SEC 2024-02 DE-24-087

kris pastoriza

January 6, 2025

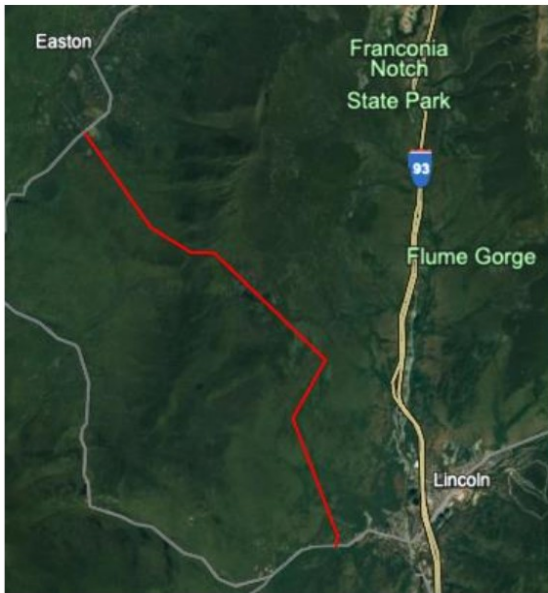
At its [June 20<sup>th</sup>](#) presentation to the PAC, when Eversource was asked for an updated count of structures in each category, Chris Soderman stated: “That was not the intent. Um, you know, again, recognizing that, you know the existing identified C structures and the condition of the transmission line and our overall strategy, you know, we kind of already thought that it stood on its own. So we weren't intending to kind of come back, but it does kind of speak to the underlying issue that these lines are continuing to deteriorate as they just age over time.” It announced “2024 drone inspections are ongoing and additional priority C structures may be identified.” VELCO’s representative commented; “if it were us, I think we would wait on sections one and two, do them at some later time...” When asked about the location of the 41 structures Eversource claimed were Category C, Chris Soderman said “Yeah, uh, specifically we don't provide that as part of the ISO PAC proceeding.”

This may be because only one Category C structure is in White Mountain National Forest, as the 2022 inspection notes Eversource provided to the SEC on 12/13/24 show.
